PB-1011 HP100-KBD24 & HP100-B23 Withdrawal Notice

HP100-KBD24/HP75-KBD24 Comparison

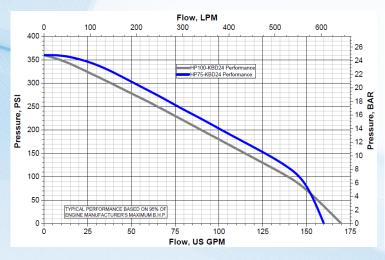
Externally, there is no appreciable difference between the HP75 and HP100 variants so no truck design changes are required. Internally the HP75 units utilize a high pressure impeller that offers a broader performance envelope compared to its HP100 counterpart. This means better low flow, high pressure performance where you need it most. Please see the performance curves below for pump comparison.
